ADDRESS : 238 CHESAPEAKE RD SUBDIV: RICHMOND PARK PH2
CONTRACTOR : KUSZMAUL, GLENN CRAIG PHONE : (919) 302-4988
OWNER : MADONNA DOMINIQUE & CORY H PHONE :
PARCEL : 09-9565-03- -0282- -14-
APPL NUMBER: 17-50043000 CP ADD & ALTER RESIDENTIAL
DIRECTIONS : T/S: 12/28/2017 12:08 PM LLUCAS ----
RICHMOND PARK #436

PERMIT: CPBP 00 CP BUILDING PERMIT

VIOLATION NOTICE

Job JJO180110	Truss T2	Truss Type Attic	Qty 1	Ply 2	cameron	E11887892
------------------	-------------	---------------------	----------	----------	---------	-----------

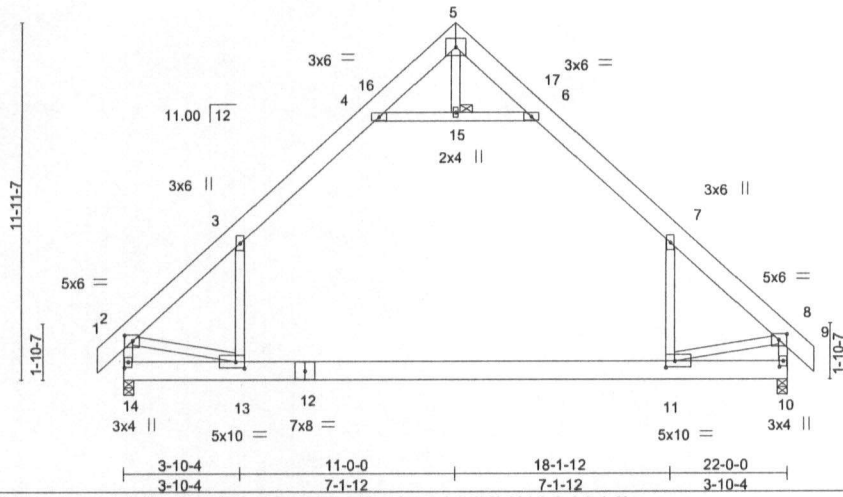
TYP/SQ	REQUESTED COMPLETED	INSP RESULT	DESCRIPTION RESULTS/COMMENTS
R425 01	6/12/18 6/12/18	TSG DA	FOUR TRADE ROUGH IN TIME: 17:00 VRU #: 003138674 T/S: 06/11/2018 01:58 PM LLUCAS ----- 1-need truss drawings and layout 2-insulate all pipes and traps in garage ceiling 3-contractor is required to contact the office to review palns and consruction cost. 4-install correct nails in two ply truss hangers.
R425 02	7/05/18 7/05/18	TSG DA	FOUR TRADE ROUGH IN TIME: 17:00 VRU #: 003147667 T/S: 07/03/2018 11:09 AM LLUCAS ----- T/S: 07/05/2018 04:45 PM DJOHNSON ----- 1. INSTALL INSULATION VENTS AND BAFFLES WHERE REQUIRED. 2. INSTALL AIR BARRIER ALONG LEFT SIDE OF STAIRS TO BONUS AREA. 3. INSTALL PROPER BATH EXHAUST TERMINATION AT SOFFITT. 4. FIREPLACE NOT VENTED. 5. FIREBLOCK HVAC CHASE IN MASTER BATH. 6. ENGINEERING REPAIR LETTER REQUIRED FOR BONUS ROOM TRUSS. 7. SECURE WATER LINES GOINT TO BONUS ROOM SHOWER. 8. FIREBLOCK TOP OF CHASE IN BONUS ROOM BATH AREA.
